January 26, 2015

Re: Addendum #2  
Roof Replacement Project  
The Laundry Building  
Herman M. Holloway Sr. Campus - Contract No. MJ3505000027

STATE OF DELAWARE  
HERMAN HOLLOWAY CAMPUS  
LAUNDRY BUILDING  
NEW CASTLE, DE

ABANDONED PROJECTION  
REMOVAL DETAIL  
OVER 2' X 2' IN SIZE  
DETAIL #D-AP-100

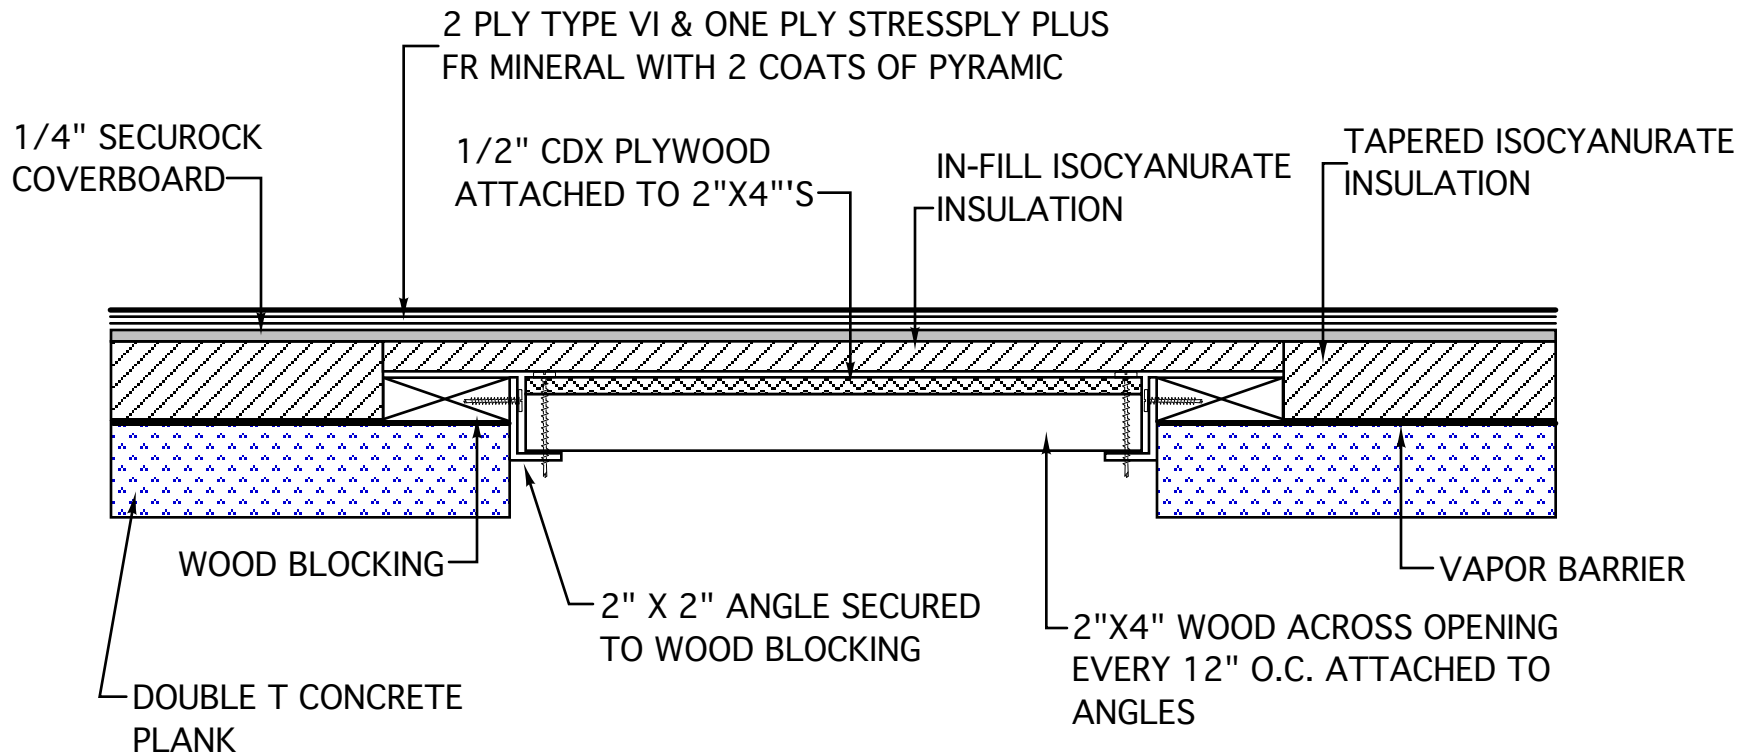
2.2 Where Openings in the Deck will be Greater Than 2' x 2': (Detail #D-AP-100)

- a. The projection and curb will be removed. Workmen must wear safety harnesses when working within 6 feet of the opening in the deck.
- b. Wood blocking will be installed around perimeter of opening. Grade "A" wood blocking will be secured to the deck with two (2) rows of approved fasteners spaced every 18 inches on center, staggered pattern. One (1) fastener will be located within two inches of the blocking ends.

- c. On the north and south side of the opening, install a 2"x2"x1/4" angle to the inside face of the wood nailer. Angle will be fastened to the wood blocking with approved fasteners spaced every 8 inches on center. Fasteners must penetrate wood blocking by a minimum of 2 inches.

- d. Across the angle iron, install 2" x 4" lumber every 12 inches on center. 2"x4" lumber will be Grade "A" and will be fastened to the angles with self-tapping metal screws. Over the 2"x4" lumber install a solid layer of 1/2" CDX ply that will completely cover the opening. Plywood will be fastened to the 2"x4" lumber with spiral shanked nails spaced every 8 inches on center.

- e. Cover the exposed wood with the Self-Adhered Base Sheet as described in section 3.0 of this Addendum. Across the primed concrete deck and wood cover, install the vapor barrier as specified.

- f. The tapered polyisocyanurate insulation will be installed across the vapor barrier to butt up tightly to the wood blocking. Over the plywood, in-fill with polyisocyanurate insulation match height of the surrounding tapered polyisocyanurate insulation.

- g. Over the polyisocyanurate insulation install the 1/4" Securock insulation and the roof system as specified.
